TO: Mercedes-Benz Dealer Principals, General Managers, Sales Managers, Service Managers, Parts Managers	FROM: Gregory Gunther, Department Manager, Vehicle Compliance and Analysis, Engineering Services
RE: Recall Campaign Launch Notification Check Electric Heater Ground Connection MY21 GLE-Class (V167 platform)	DATE: December 22, 2021

Campaign No. 2021120004, December 2021

SUBJECT: **Model GLE-Class (167 platform)**
Model Year 2021
Electric Heater Ground Bolting

Figure 2

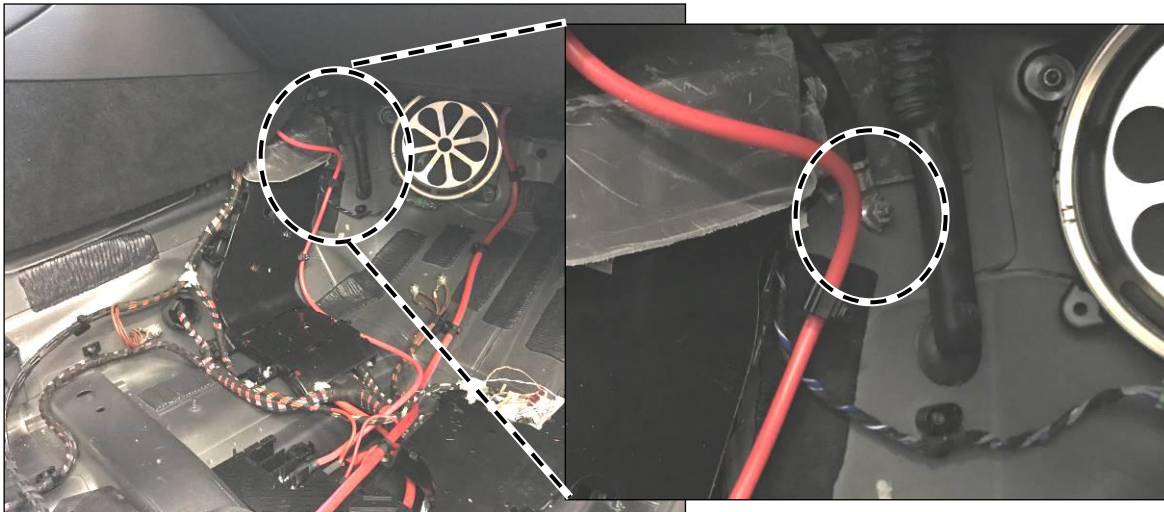
3. Check for scorch marks in area of ground connection of PTC booster heater (**Figure 2**).
4. Check ground connection of PTC booster heater as to whether loose or tightened with correct torque (**Figure 2**).

i **Figure 2** shown with removed floor covering!

i The torque of the ground connection **must** be **Nm** 10!

- a. **Scorch marks present** in the area of the ground connection:
Carry out **work procedure**.
- b. **Scorch marks not present** in the area of the ground connection:
End measure.
